May 17, 2005
LIC-05-0062

**SUBJECT: Fort Calhoun Station Unit No. 1, Response to Request for Additional Information on the Revised Relaxation Request for First Revised Order (EA-03-009) Establishing Interim Inspection Requirements for Reactor Pressure Vessel Heads at Pressurized Water Reactors**

## Response to Request for Additional Information on the Revised Relaxation Request for First Revised Order (EA-03-009) Establishing Interim Inspection Requirements for Reactor Pressure Vessel Heads at Pressurized Water Reactors

The basic component arrangement of the system is shown in Detail "A" (upper components) and Detail "B" (lower components). The components of interest in this discussion are as follows:

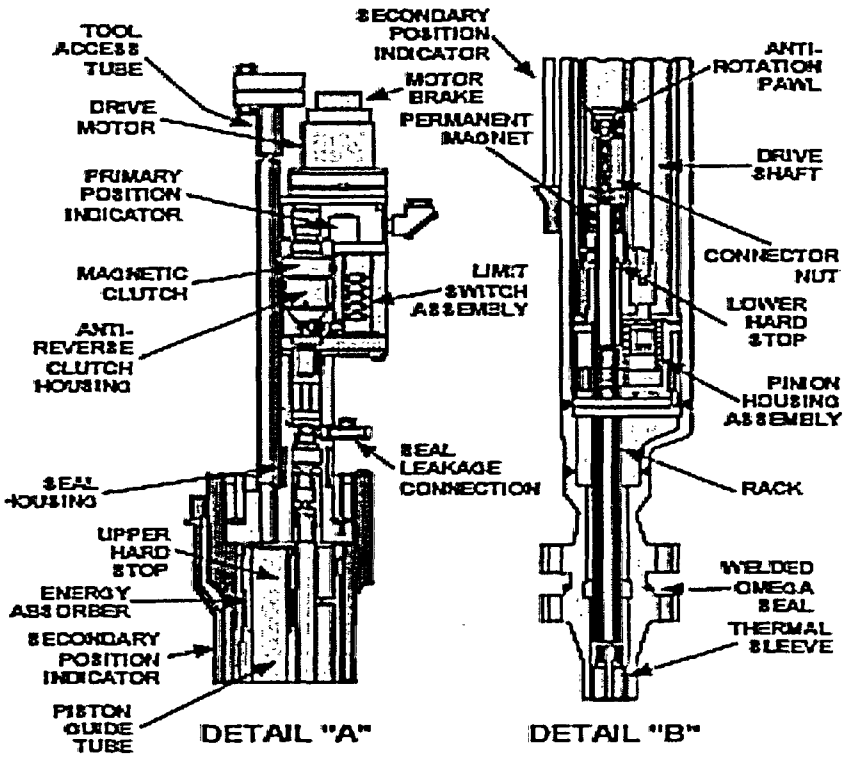
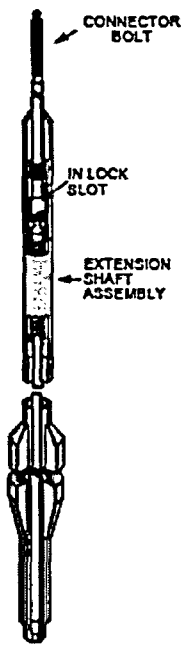
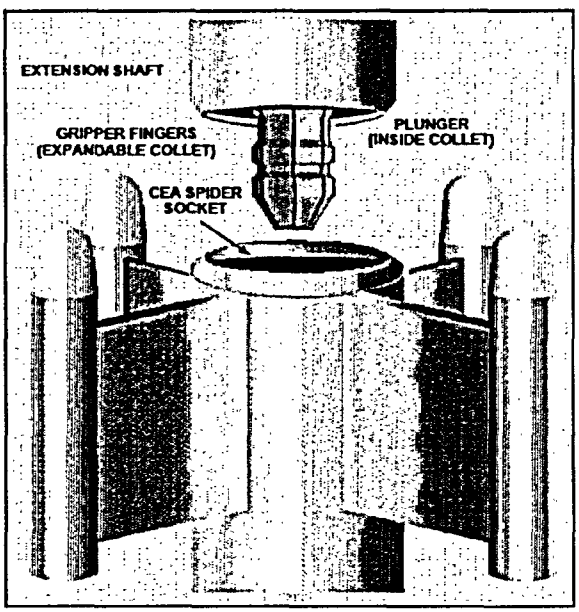
Please provide a detailed explanation of the hardship associated with removal of the thermal sleeve for Control Element Drive Mechanism (CEDM) penetration nozzle 25.

The rod control system at Fort Calhoun Station Unit No. 1 (FCS) is a unique design that uses a rack and pinion CEDM. Palisades is the only other plant with rack and pinion CEDMs, but their configuration under the reactor pressure vessel (RPV) head is very different from FCS, in that their CEDM extension shafts can be removed from the top. The rack and pinion design imposes a significant constraint on performance of a RPV head inspection because the CEDM extension shaft that connects the drive mechanism to the Control Element Assembly (CEA) remains installed in the RPV head nozzle when the reactor is disassembled. The presence of the CEDM extension shaft severely limits access to the nozzle inside diameter (ID) for inspection purposes. Inspection access is further complicated by the thermal sleeve that is installed in the annulus between the CEDM extension shaft and the CEDM nozzle.

FCS has a "scram weight" at the end of each CEDM extension shaft that precludes CEDM extension shaft removal from the top of the RPV head, necessitating their removal from below the RPV head (See Reference 1, Attachment 1, Figure 3, Page 15). Palisades does not have these weights and can remove their extension shafts from the top of the RPV head.

The CEDM extension shaft assembly is inserted through the CEDM nozzle from underneath the RPV head and extends through the rack into the piston guide tube.

In order to remove the CEDM extension shaft on CEDM nozzle 25, the RPV head will be installed on the reactor vessel and the CEDM extension shaft will be lowered until it rests on the CEA spider. The CEDM connector nut will then be removed and the reactor head will be lifted and placed on the head stand. It is anticipated that the CEDM extension shaft will be left resting in the Upper Guide Structure in the reactor vessel. However, since this operation has never been performed, it is not certain that the CEDM connector bolt will disengage smoothly from the CEDM rack assembly and slide downward while the RPV head is being lifted. Additional rack extensions may need to be removed to gain proper clearance and a pathway to access CEDM nozzle 25.

With the CEDM extension shaft(s) removed, the RPV head will be placed in the head lay down area. The configuration of the thermal sleeve cutting equipment requires the RPV head to be raised approximately two feet above the normal resting height. Due to the tight clearances in this area, this additional two feet of height will require removal of interferences and rotating the RPV head into an off-normal orientation. The thermal sleeve will be cut above the CEDM nozzle inspection area and removed. The cutting operation will be performed using precision cutting equipment to avoid any possibility of damage to the CEDM nozzle ID. Industry experience has shown, however, that there is a risk of introducing tool marks on the ID of the nozzle. Special cutting equipment is required to perform this operation because the thermal sleeve will be cut approximately 24 inches above the bottom of the CEDM nozzle. Once the thermal sleeve has been cut and removed, additional special tooling will be used to reinstall the original "flare" on the remaining end of the thermal sleeve. The flare is required to prevent interference with the CEDM rack as it raises and lowers the CEA.

**Attachment 1, Figure 1**

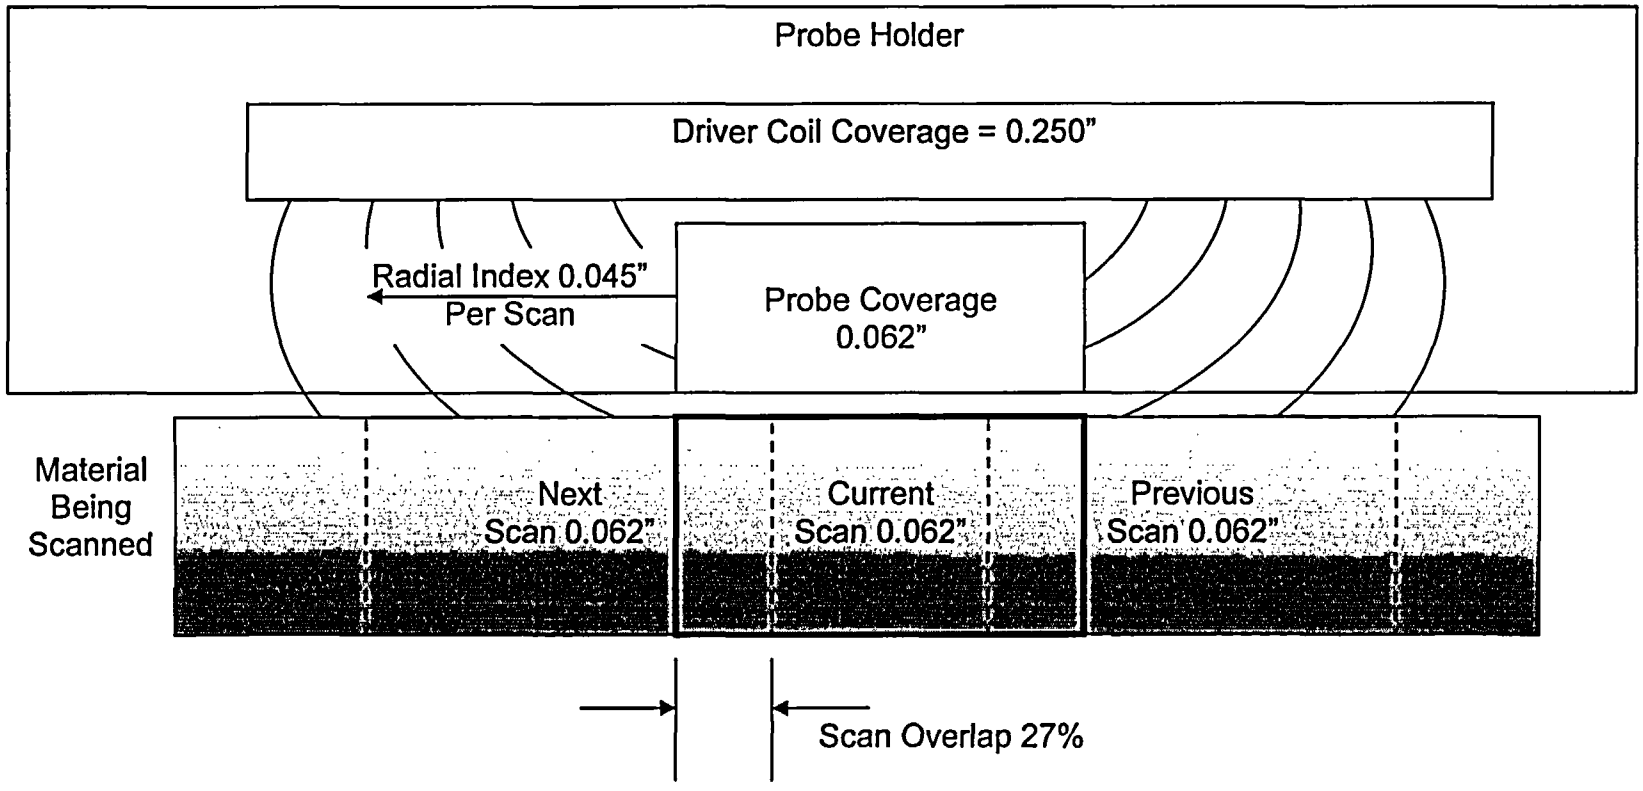
Please provide a detailed explanation to support the position that missing a single scan line is acceptable.

Various CEDM nozzles have single missing scan line information in some areas. OPPD has determined in each case that a single missing scan line does not prevent determination of a potential significant flaw, due to the amount of overlap of adjacent scan line coverage in adjacent eddy current traces. These areas are considered to be fully inspected.

The geometry of the probe and driver coil in combination with size of the scanning grid and the defined overlap ensures that any indication, regardless of width or length, will be observed. Adjacent scan lines have an overlap of 27% as shown on Figure 1. This criterion is based on the number and location of sensors in the probe and the overlapping regions of sensitivity resulting from the scan line increment assuring that a valid indication of relevant length should be evident. An indication picked up in one scan line will also be seen by the adjacent scan lines. A missing scan line is most likely caused by small boric acid on deposits or crud accumulation on the nozzle or thermal sleeve surface which causes axial travel resistance on the probe.

Due to features in the scanning mechanism that prevent the probe delivery device from exceeding allowed force limits (intended to prevent probe failure during the scan), the probe automatically retracts when sufficient resistance is detected and begins to scan the next line.
